date: June 20, 2024
to: Jennifer Hofmeister-Drew, AICP, LCAM, Planner III,
Town of Palm Beach
from: Eric Czerniejewski, P.E., ENV SP
subject: Paramount Palm Beach Traffic Review

MEMORANDUM

Figure 212.11.1 Clear Sight Triangles

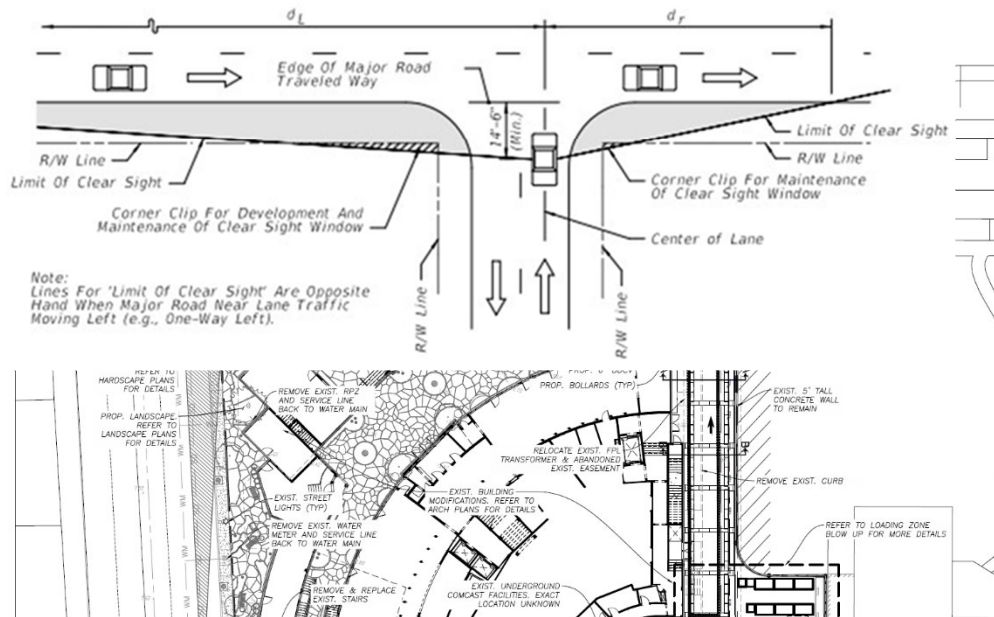
11. Please provide sight visibility triangles on the site plan at each of the driveway connections. The sight triangles should also be depicted on the landscape plans and the pavement marking and signage plans. This includes evaluation of the sight distance at the egress only driveway connection to Sunrise Avenue. The sight triangles along NE 163rd Street/SR 826 should meet FDOT criteria as outlined in the FDOT Design Manual (Section 212.11). Please update these sight triangles accordingly

Kimley Horn and Associates, Inc.'s 04/10/24 Response: Based upon information provided by Keshevarz & Associates, Inc., Driveway sight visibility triangles have been depicted pursuant to the Town's Right of Way Standards Manual consisting of a 15'x8' sight triangle. Based on the Town's Right of Way Standards manual.

TCG 05/09/24 Response: Addressed. This item is subject to approval by the Town of Palm Beach Public Works Department.

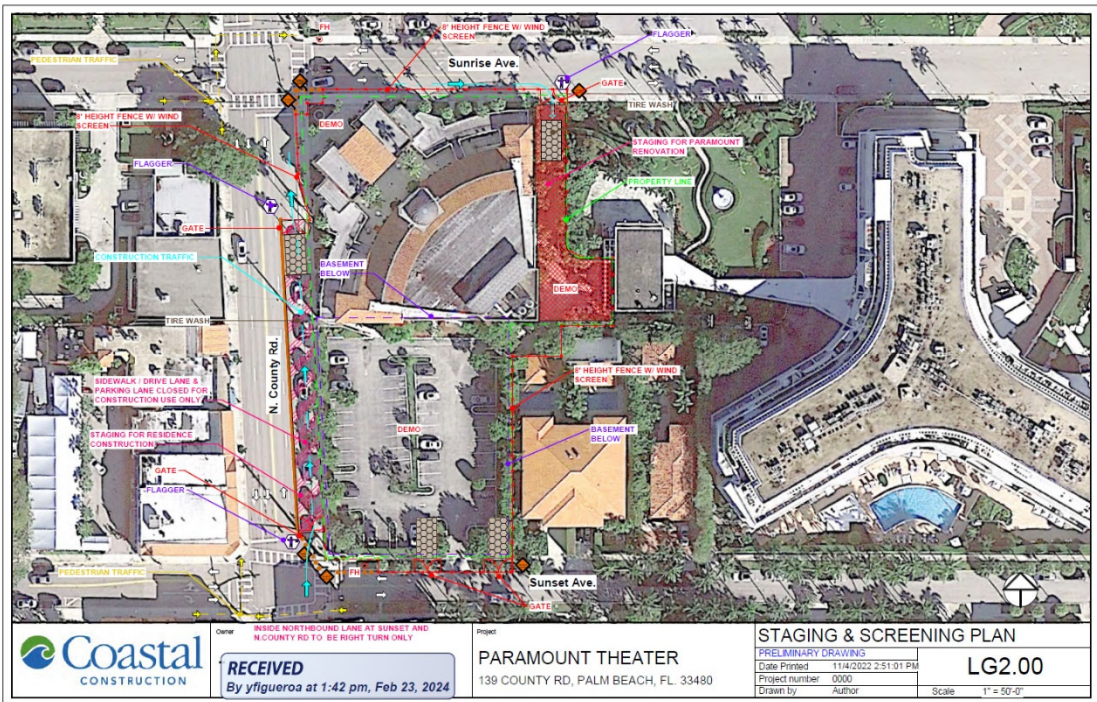
12. Please provide a separate pavement marking and signage plan signed and sealed by a professional engineer. Please ensure that the appropriate signage per MUTCD is provided for movement restrictions at the proposed ingress and egress locations included stop signs and Do Not Enter/One-Way signs. The pavement marking and signage plan should include the dimensions and existing pavement markings for the existing surface parking lot. The pavement marking and signage plan should also provide dimensions and geometry (including entrance radii) of each of the driveway connections (ingress only at Sunset Avenue and egress only at Sunrise Avenue). There should be stop bars at the appropriate locations to achieve acceptable stop control, sufficient sight distance and safe pedestrian crossings/crosswalks. Please include typical handicap and regular parking stall details per Town of Palm Beach criteria. The only civil engineering plan sheet provided was plan sheet C-1 which was a utility adjustment plan.

Kimley Horn and Associates, Inc.'s 04/10/24 Response: No modifications are proposed for the existing parking areas onsite with the exception of additional landscaping. Detailed pavement markings and signage plans will be prepared by Keshevarz & Associates, Inc. and will be submitted during the Construction Plan approval process. The Applicant commits to working with Town staff to make adjustments as appropriate for enhanced ADA accessibility.

TCG 05/09/24 Response: This item is still pending. A condition of approval will be developed which requires the project to address all traffic engineering related comments of the pavement, marking and signage plans once submitted.

Kimley Horn and Associates, Inc.'s 05/31/24 Response: Detailed pavement markings and signage plans will be prepared by Keshevarz & Associates, Inc. and will be submitted during the Construction Plan approval process.

TCG 06/20/24 Response: Addressed. This item is subject to approval by the Town of Palm Beach Public Works Department.
